Subject: Site Plan #20-002 Koppert Biological Systems-Building Addition

Recommended motion for Site Plan Application #20-002 (Koppert Biological Systems-Building Addition)

Re: Site Plan Review
Koppert Biological Addition
1502 Old US Hwy 23

ARCHITECTURAL SITE PLAN
 NORTH
 TAX ID: 44709-28-100-024
 ZONING: LIGHT INDUSTRIAL
 1" = 30'-0"

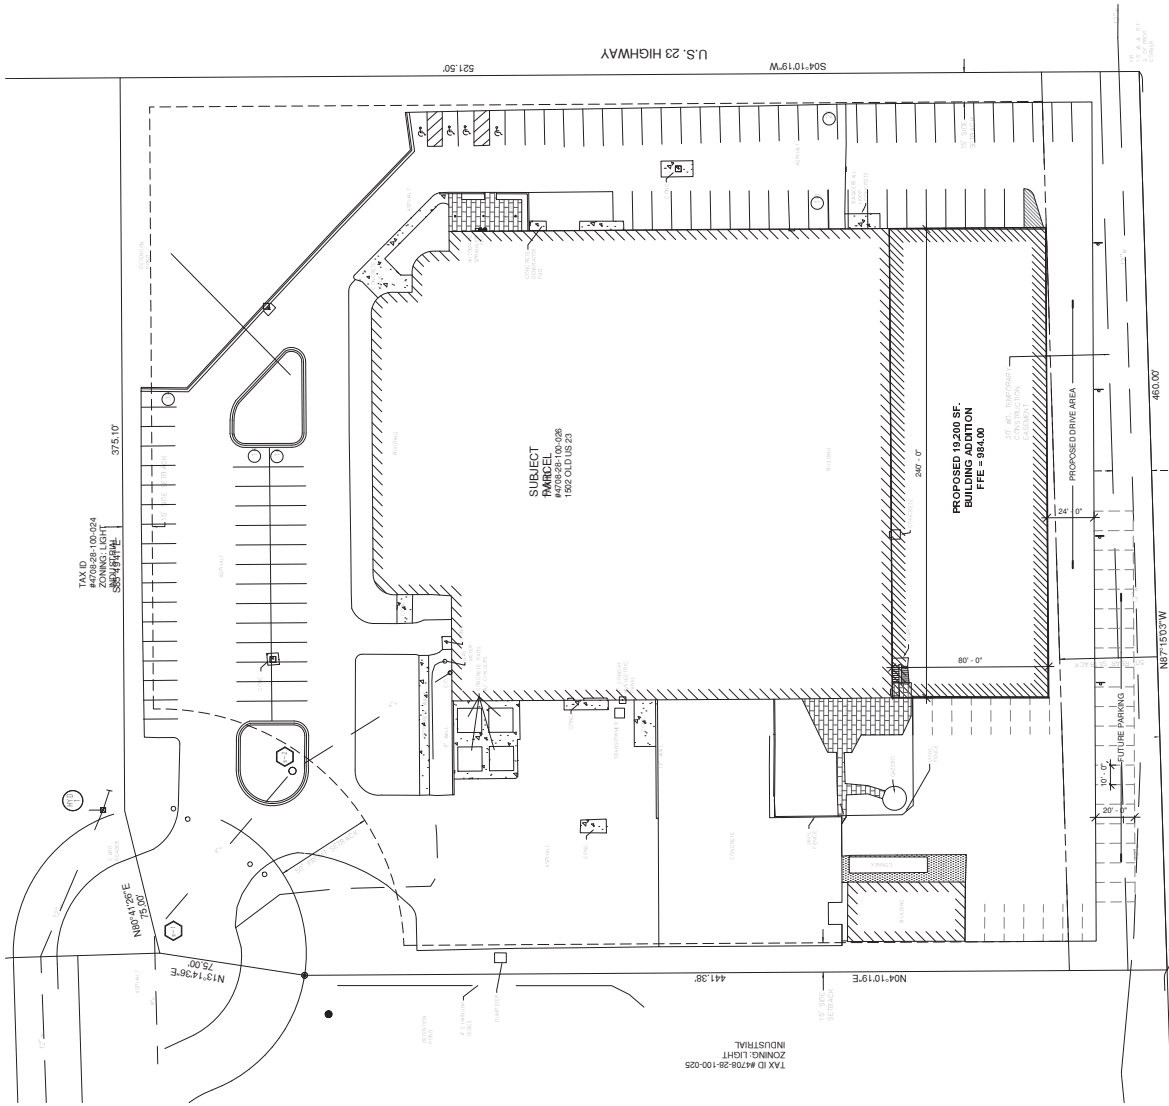
- Meets Requirement? – **TBD**
- Comment – **Applicant has requested a waiver to deviate from the Off-Street Parking standards (Sec. 5.8), to construct twenty-three (23) spaces on the east side of the proposed building addition and defer the construction of thirty-three (33) spaces (located west and south of the addition); thus providing a total of 100 off-street parking spaces, and not 133 parking spaces as required per standards outlined in Sec. 5.8.**

Per the applicant, employees of Koppert Biological Systems currently occupy approximately one-half of the existing seventy-seven (77) parking spaces, and the addition will not impose a parking load that will exceed the available parking. Thirty-three (33) parking spaces are shown as deferred parking, should additional parking be necessary in the future. The deferred parking spaces occur along the south and west sides of the building addition. The applicant noted deferral of constructing thirty-three (33) parking spaces will reduce the unnecessary paving.

Planning Commission to review the parking waiver request in consideration with the provisions outlined in Section 5.8.2.F, (Deferred Parking).

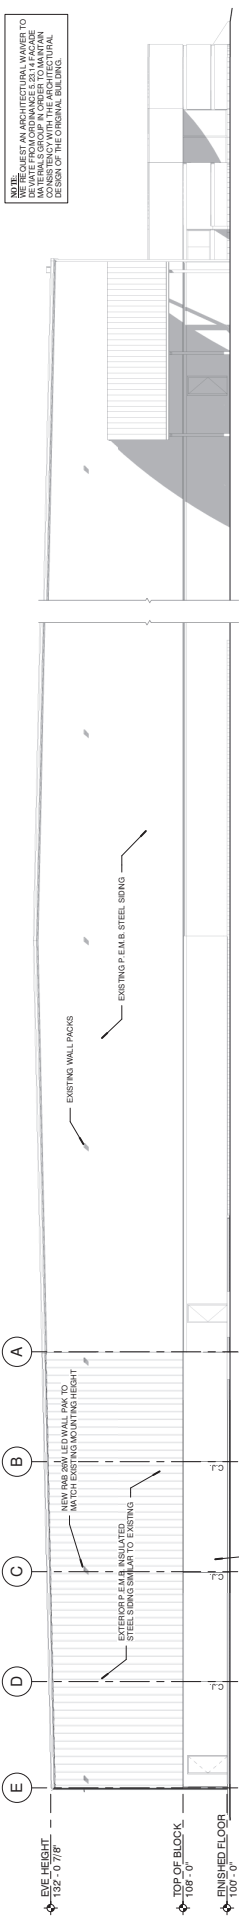
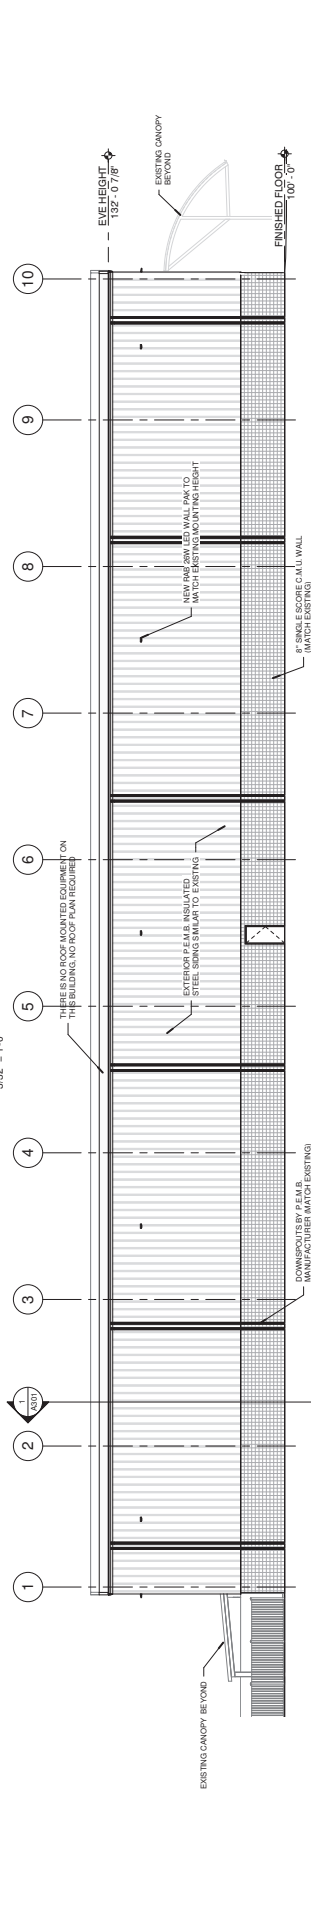
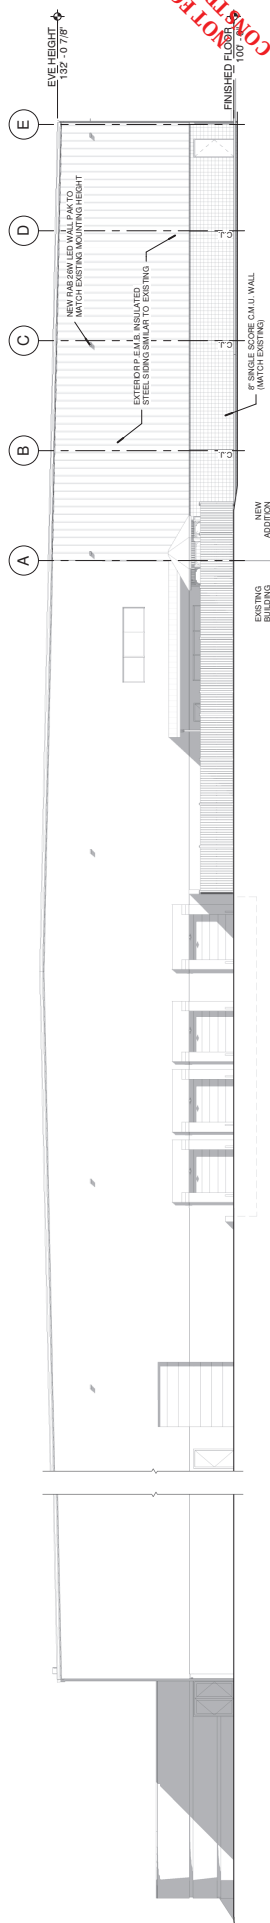
The applicant intends to continue the existing architectural theme for the current project, using metal vertical siding and EFIS on all three (3) sides of the proposed building addition. A waiver request was submitted, to deviate from Section 5.24, for façade materials.

- Required – comply with Sec. 5.24.14 Facade Materials Chart (Group #1A)
- Proposed – continuation of existing façade materials (metal vertical siding and EFIS)
- Meets Requirement? – **TBD**
- Comment – **Applicant has requested a waiver to deviate from the Architecture Standards (Sec. 5.24 and 5.24.14), and continue the existing architectural theme, by using taupe-tone metal vertical siding and an 8-foot tall beige EFIS wall at the base, on all three sides of the building addition.**

Planning Commission to review the façade materials waiver request in consideration with the provisions outlined in Section 5.24.8. (Additions).

- A. The addition does not exceed one hundred (100) percent of the existing building floor area;
- B. All new facades substantially constitute a continuation of the existing facades with respect to color, texture, size, height, and location of materials; and
- C. That the visual effect is to make the addition appear as part of the existing building.
